Access Compliance Report Public Rights-of-Way (Curb Ramps)

Main Street: CAPRICORN_DR Cross Street: GOSSAMER_PL Location: SE

ADA ID: RPAT211101101159 Ramp Type: Type 4 - Parallel Initial Pass/Fail: Pass Overall Compliance: No Severity Score: 16

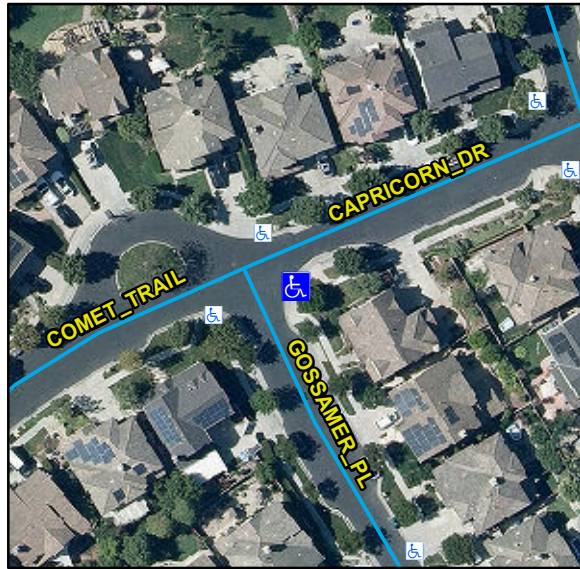
Compliance	Description	Data	Compliance	Description	Data
N/A	Ramp Length LT (in)	110	N/A	Ramp Length RT (in)	98
Yes	Ramp Width LT (in)	53	Yes	Ramp Width RT (in)	53
Yes	Ramp Run Slope LT (%)	5.1	Yes	Ramp Run Slope RT (%)	5.9
Yes	Ramp Cross Slope LT (%)	0.4	Yes	Ramp Cross Slope RT (%)	1.5
N/A	Landing Present	Yes	No	DWS Provided	No
N/A	Landing Length (in)	53	N/A	DWS Contrast	N/A
Yes	Landing Width (in)	60	N/A	DWS Length (in)	N/A
No	Landing Run Slope (%)	2.4	N/A	DWS Full Width	N/A
Yes	Landing Cross Slope (%)	0.5		DWS Offset Type	N/A
N/A	Landing Movement Obstructed?	No	N/A	DWS Offset Left (in)	N/A
	Landing Movement Type	Curb	N/A	DWS Offset Right (in)	N/A
N/A	Landing Shared	No			
N/A	Clear Space	Yes			
N/A	Clear Space To Crosswalk (in)	48			
N/A	Marked Crosswalk 1	No	N/A	Marked Crosswalk 2	No
	Crossing 1 Direction	N		Crossing 2 Direction	W
	Marked Crosswalk 1 Width (in)	N/A		Marked Crosswalk 2 Width (in)	N/A
N/A	Ramp Inside Crosswalk 1	N/A	N/A	Ramp Inside Crosswalk 2	N/A

Crossing 1 Slope (%)	0.8		Crossing 2 Slope (%)	0.8
	Crossing 1 Cross Slope (%)	1.1		Crossing 2 Cross Slope (%)	0.4
Yes	Gutter Ponding	No	No	Curb Slope	12.3
Yes	Gutter Lip Height (in)	0		Road Run Slope (%)	1
No	Gutter Run Slope (%)	12.2		Road Cross Slope (%)	0.8
Yes	Gutter Cross Slope (%)	1.4	No	Perpendicular Joint Present	No
Yes	Overall Surface Condition	Acceptable			
	Cross Gutter Present?	No		Spandrel Present?	No
	Replace Cross Gutter?	N/A		Replace Spandrel?	N/A

Remove & Replace Curb Ramp With Two New Directional Ramps or Equivalent. Remove & Replace Gutter.
